Remodel of existing retail space into a new branch for America First Credit Union

FORM P3: ADMINISTRATIVE DECISIONS AND MINOR AMENDMENTS

Proposed site revision for the America First Credit Union tenant improvement. Remove portion of existing storefront windows and add a walk-up ATM to the existing exterior wall.

AFCU - ALBUQUERQUE BRANCH
 3400 HIGHWAY 528
 ALBUQUERQUE, NM

DEMOLITION ELEVATIONS

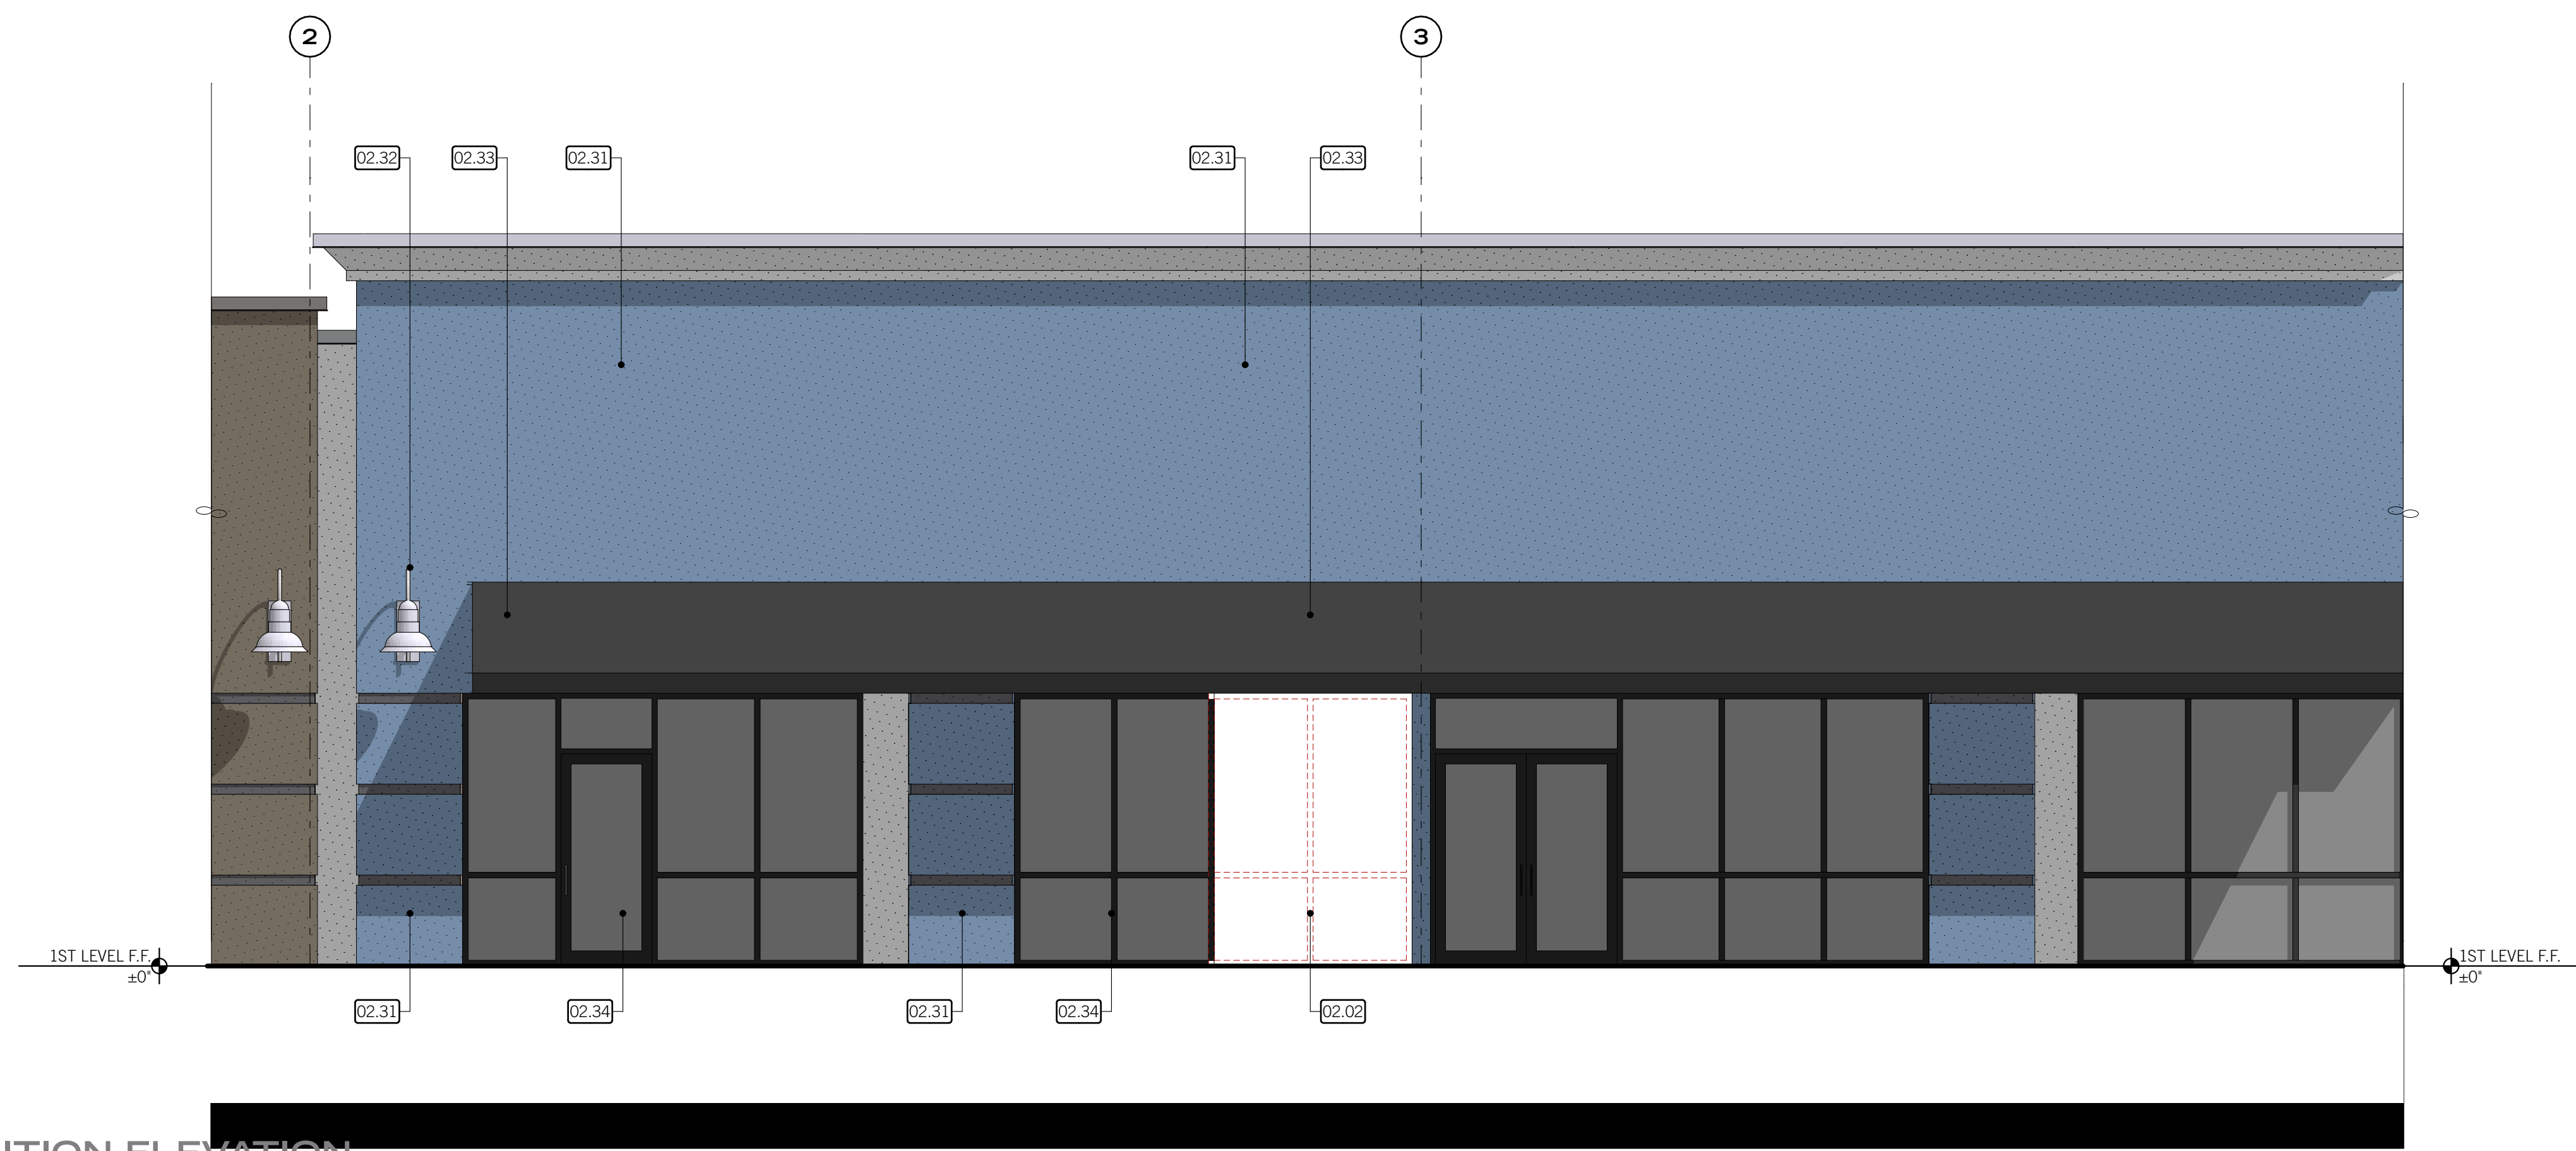
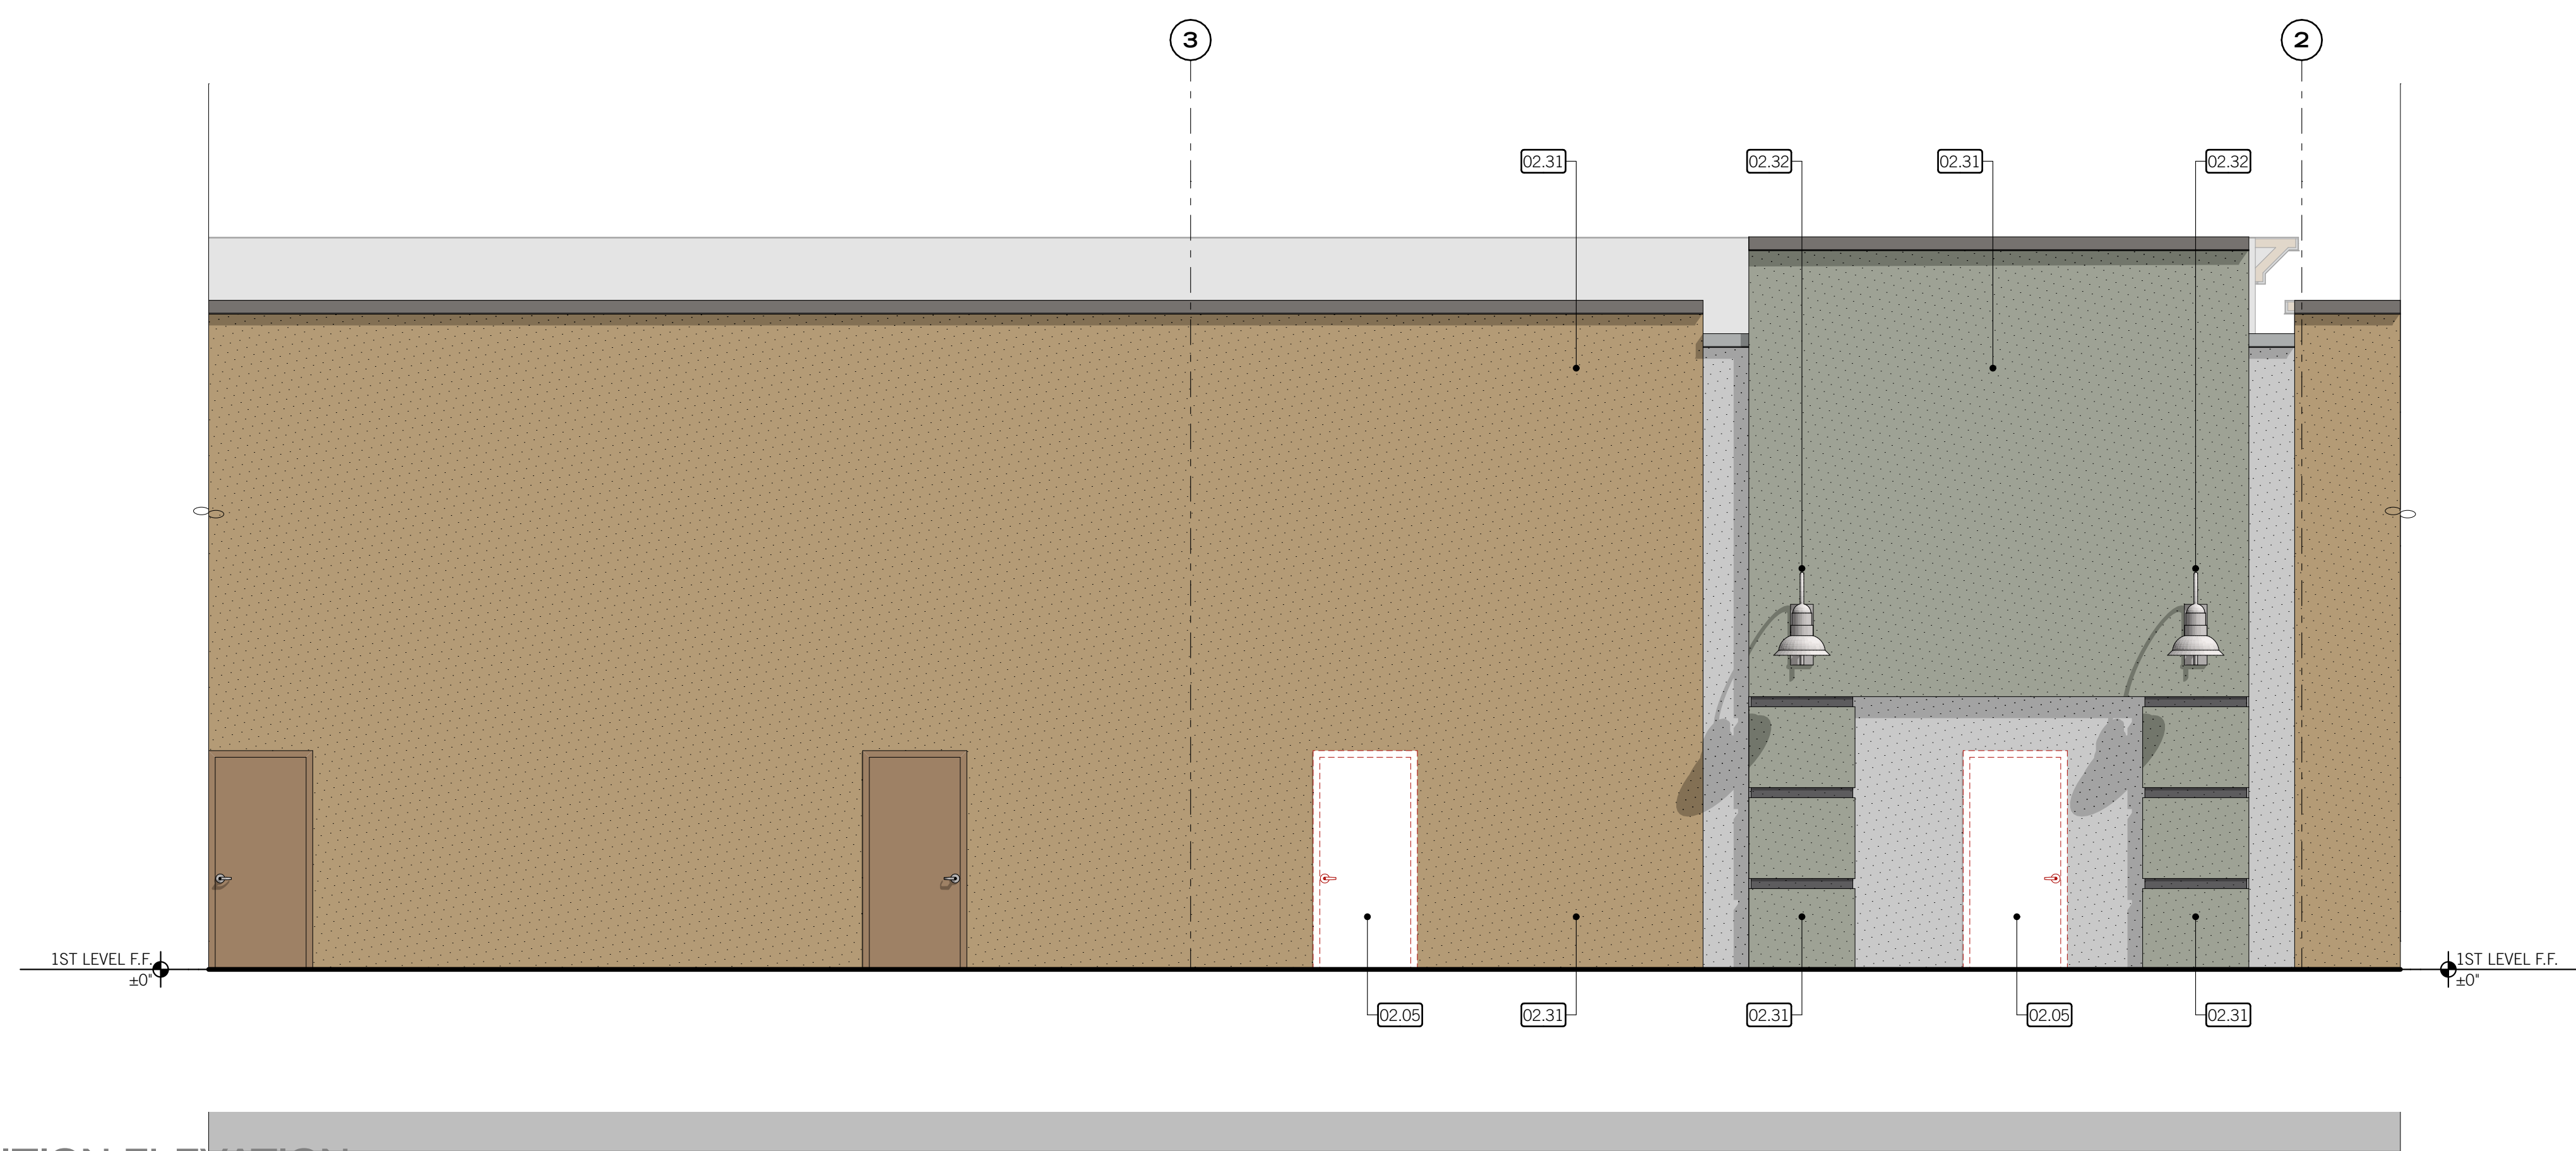
The exterior of the building will remain mostly as-is. A portion of the existing aluminum storefront system on the north side of the building will have to be removed so that a walk-up ATM can be installed. The wall will be infilled to match the existing conditions around the ATM (please re: D1.1 and A1.1). Two hollow metal frame doors on the south side of the building will also be removed. One door will be infilled to match the existing wall type and the other will be replaced with a new door and frame.

- 02.02 Remove portion of existing aluminum storefront system as shown.
- 02.05 Remove existing metal door and hollow metal frame, complete.
- 02.31 Existing EIFS system - protect from damage
- 02.32 Existing light fixture to remain - protect from damage
- 02.33 Existing awning system to remain - protect from damage
- 02.34 Existing aluminum storefront system to remain - protect from damage

1ST LEVEL ANNOTATED PLAN

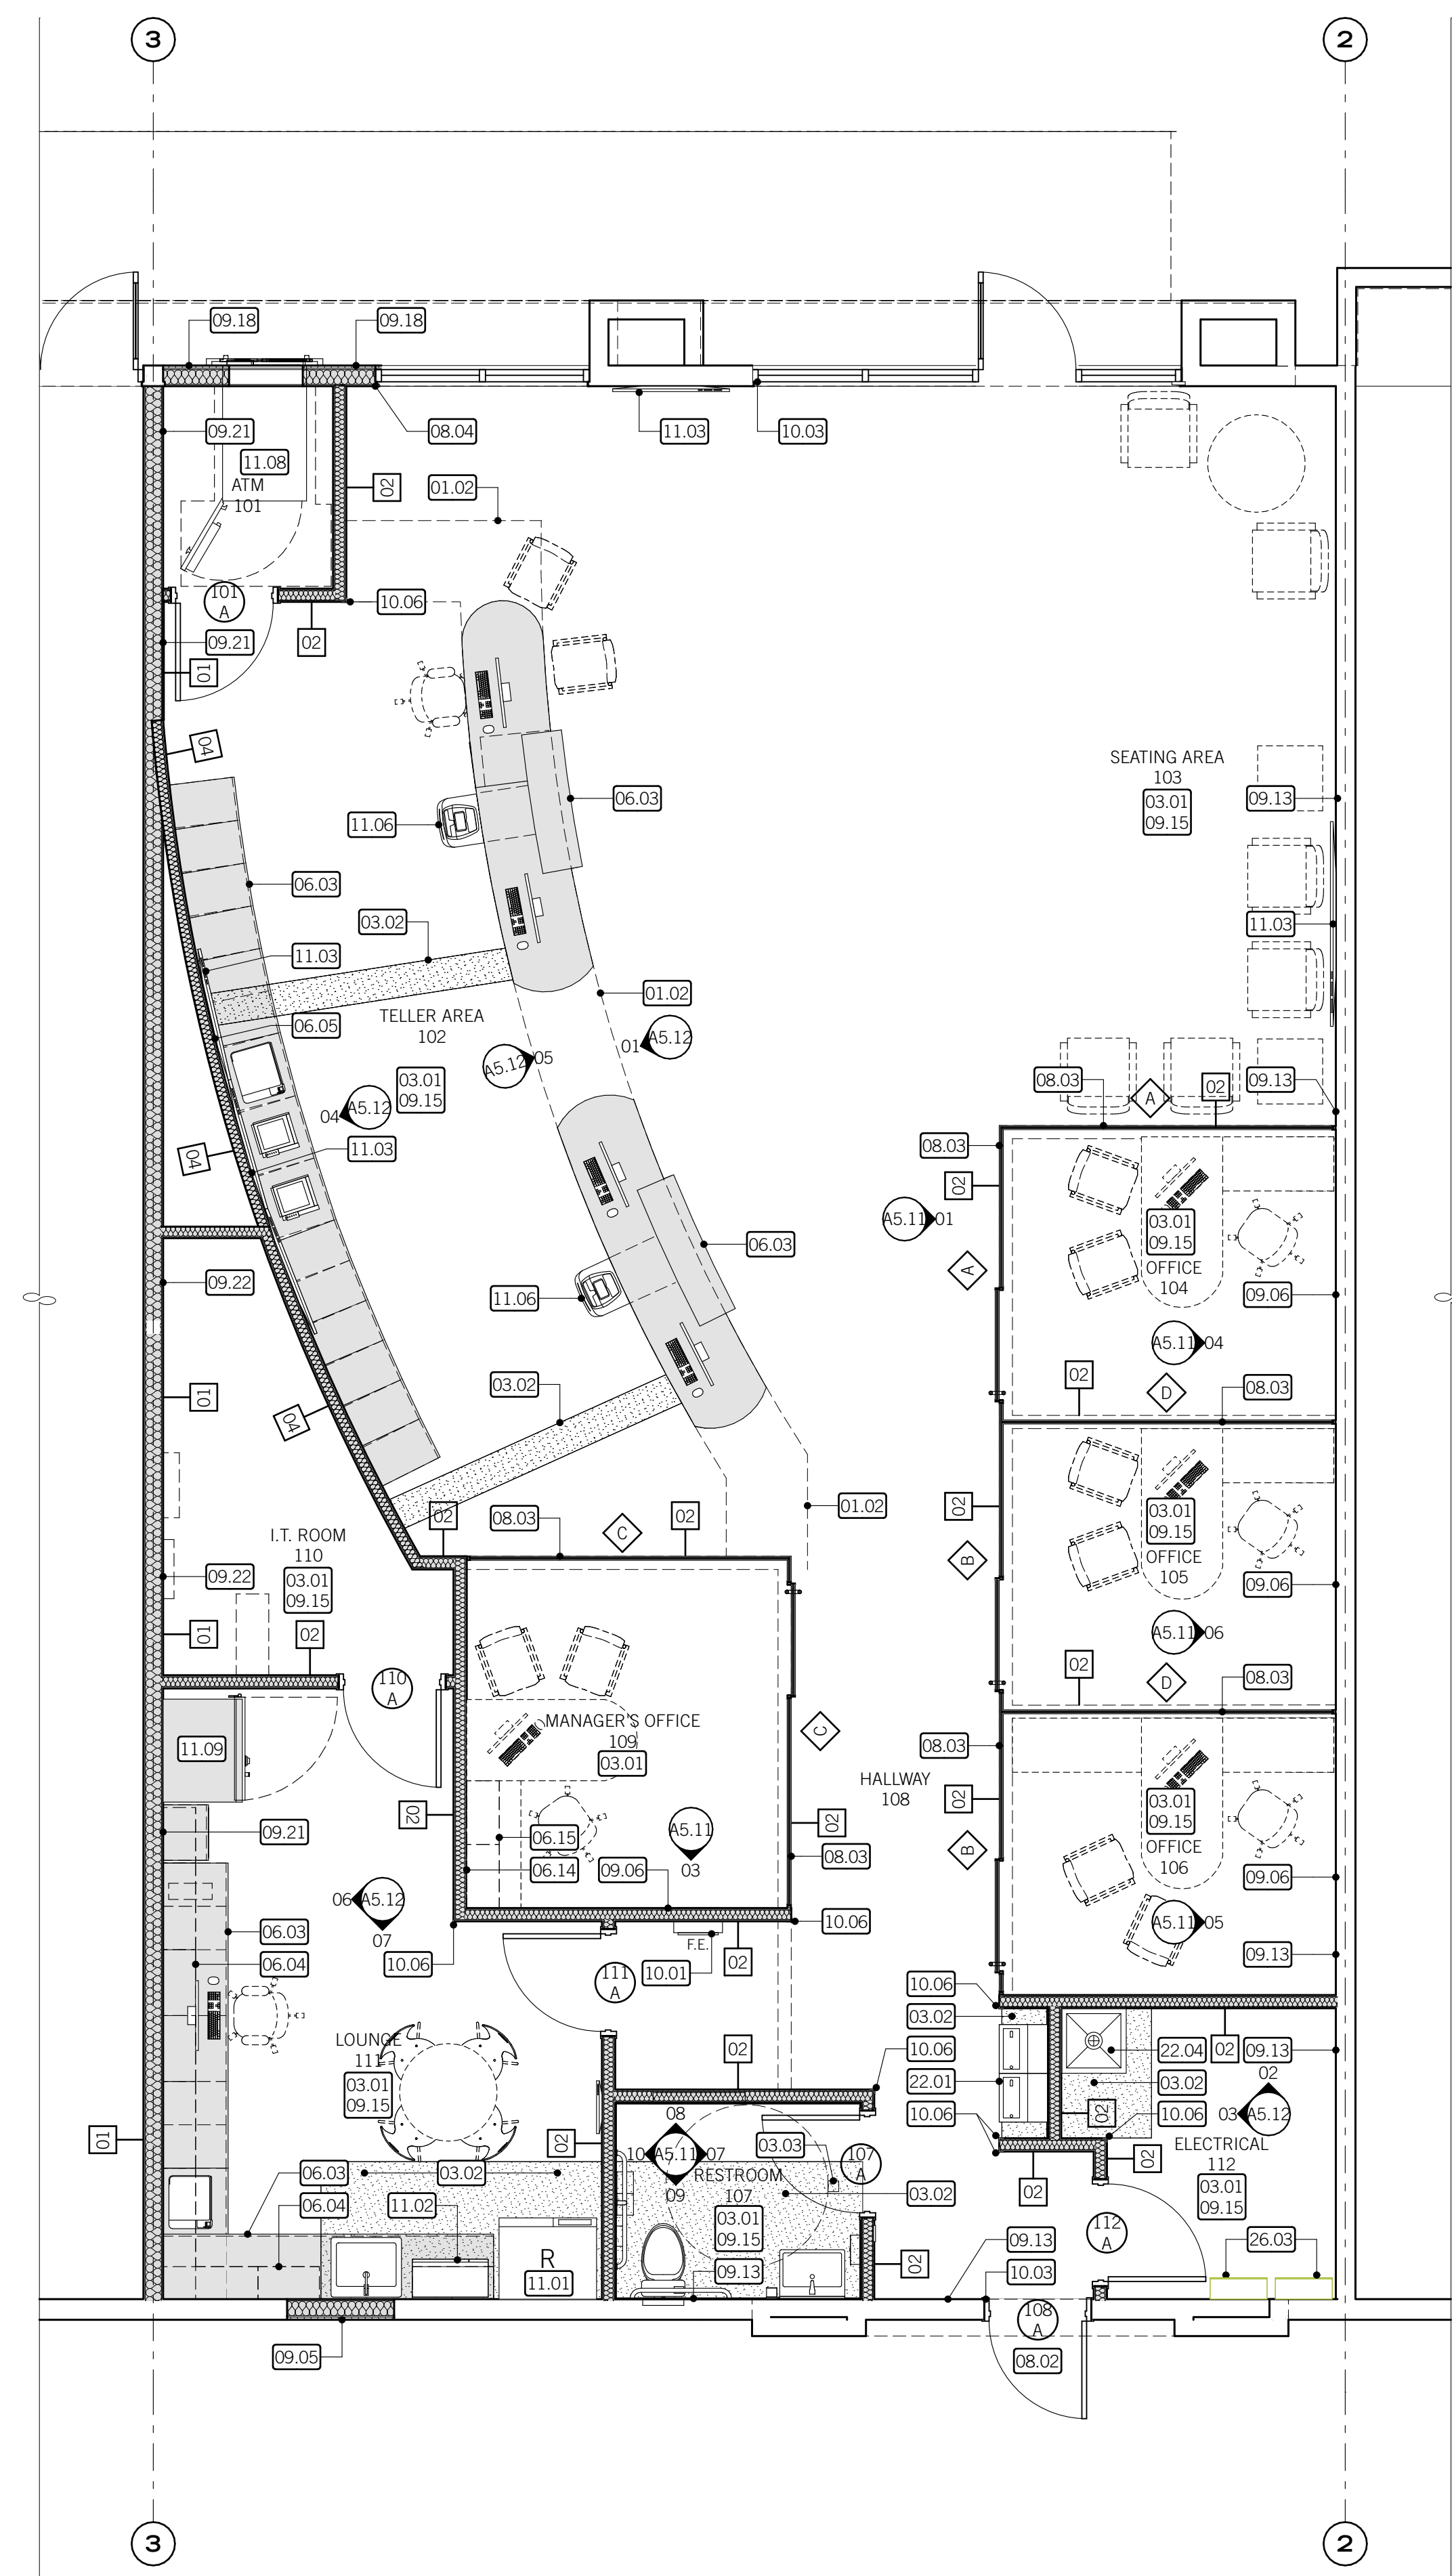
- Infill existing wood framed exterior partition with wood framing and batt insulation to match existing at location of demolished storefront system. Install 5/8" gypsum board at inside face of wall to match existing. Skim coat wall to provide smooth level finish - paint. Install plywood wall sheathing and exterior EIFS system to match existing @ exterior - re: exterior elevations. Coordinate opening dimensions with ATM supplier. Install stainless steel flashing around ATM wall opening where occurs. Paint existing EIFS adjacent to existing storefront opening to match new EIFS. Re: detail 06/A1.2.

- Cash recycler machine (N.I.C.) - provided by Owner's Equipment Contractor - re: equipment plan. Contractor to coordinate installation with millwork.
- ATM machine (N.I.C.) - provided by Owner's Equipment Contractor - re: equipment plan. Coordinate rough opening dimensions in exterior wall with Owner's Equipment Contractor. Re: detail 06/A1.2 for stainless steel flashing at opening.
